# Application Nadel and Gussman Heyco, LLC Parker 5 Federal # 6 Sec 5, T18S, R31E 1980' FSL & 2310' FWL Eddy County, New Mexico

# PECOS DISTRICT CONDITIONS OF APPROVAL

OPERATOR'S NAME: Nadel & Gussman HEYCO, LLC
LEASE NO.: NM68040
WELL NAME & NO.: Parker 5 Federal # 6
SURFACE HOLE FOOTAGE: 1980' FSL & 2310' FWL
BOTTOM HOLE FOOTAGE Same
LOCATION: Section 5, T. 18 S., R 31 E., NMPM
COUNTY: Eddy County, New Mexico

#### **EXHIBIT "D" LOCATION DIAGRAM**

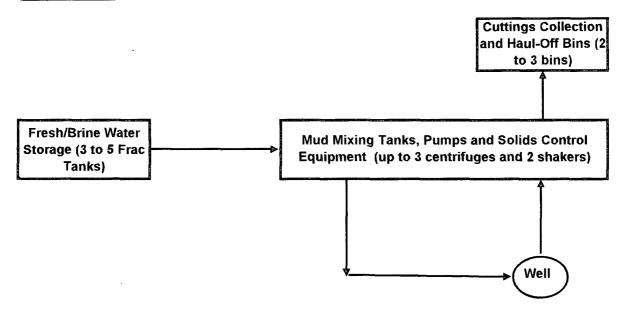
The Juniper tree located 105 feet north of the proposed well location must be preserved by placing closed loop system and equipment north (see attached Exhibit "D" Location Diagram in APD.

Closed loop system- V door east
